BCC Meeting Minutes

Parks and Recreation Board

Brewer Arena Improvements

Parks and Recreation Board
November 13, 2025

Grandstand & Pavilion Changes

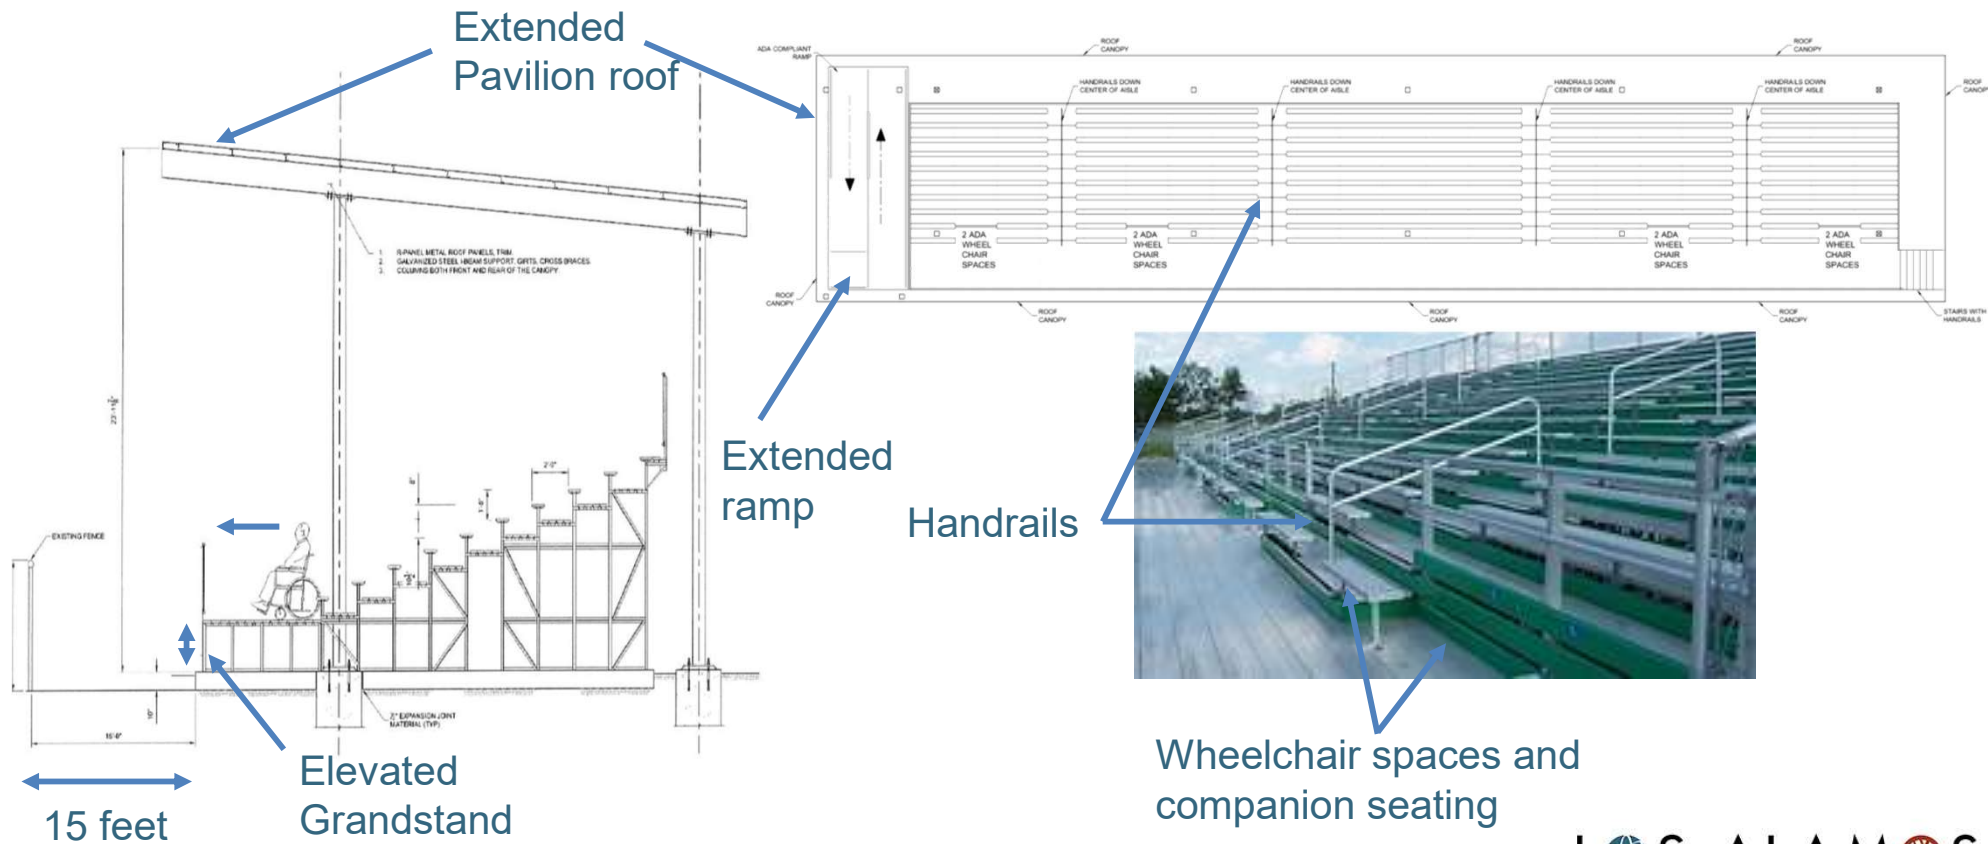
- Adjust elevation so that first row has unobstructed view over arena fence)
- Center the seating on the “50-Yard Line”
- Grandstand to be 15’ away from arena fencing (per PRCA)
 - West side arena access gates need to be unobstructed
- Make seating steps shallower/less steep and with handrails
- Extend the pavilion to provide cover for the entire seating, access ramp, and walkway.

- Increase Grandstand elevation
 - Extend ADA Ramp
- Center Grandstand on the 50-yard line
- Place Grandstand 15’ from arena fence
 - Ensure access gates unobstructed
- Seating incline meets standards
- Enlarge Pavilion

A project cost increase of **\$320,000.00**

New total project cost: **\$3,052,599.96**

ADA Parking

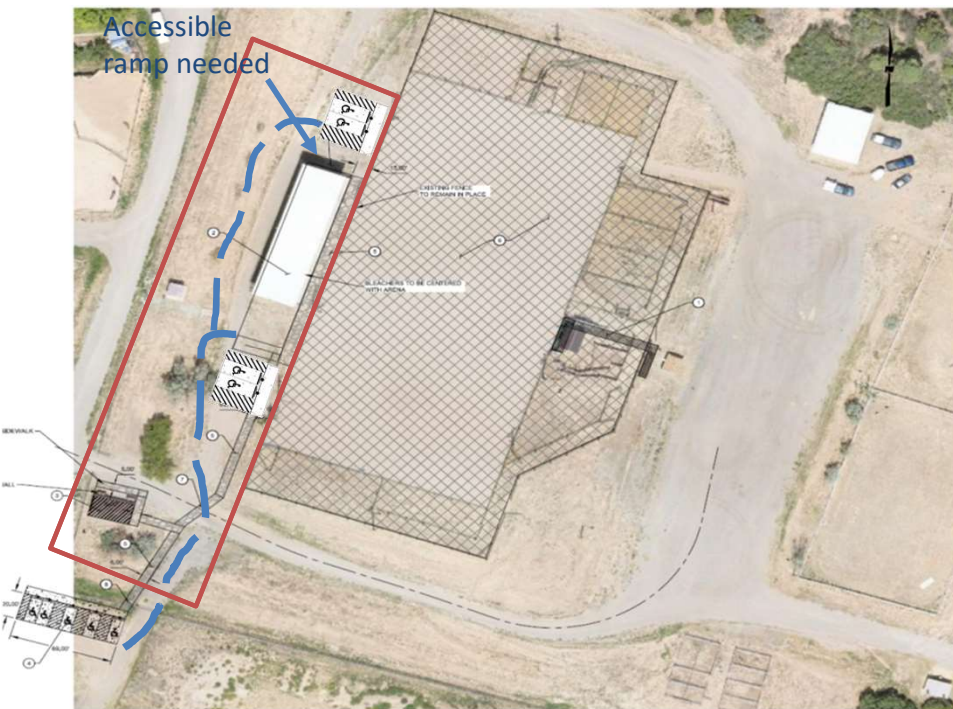
Investigate ADA parking on the north and south of the seating area

- Pros
 - Create a parking that is closer to the grandstand
 - Potentially reduce sidewalk area
- Cons
 - Pedestrian/traffic conflicts
 - Connectors between Grandstand and restroom still needed
 - Vehicle/equestrian flow interference
 - Additional site work required
 - Additional cost
- Recommendation
 - Keep ADA parking on the southside and utilize horse friendly materials on walkway

Restrooms

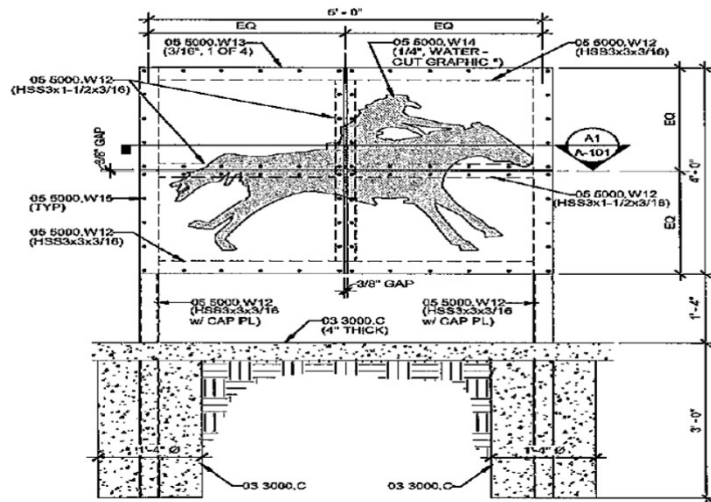
- Sink placement does not allow turnaround wheelchair access
- Restroom capacity will not satisfy the full demand

- Restroom upgrades meet ADA requirements as designed
- Restroom capacity can be increased through the placement of temporary facilities when needed
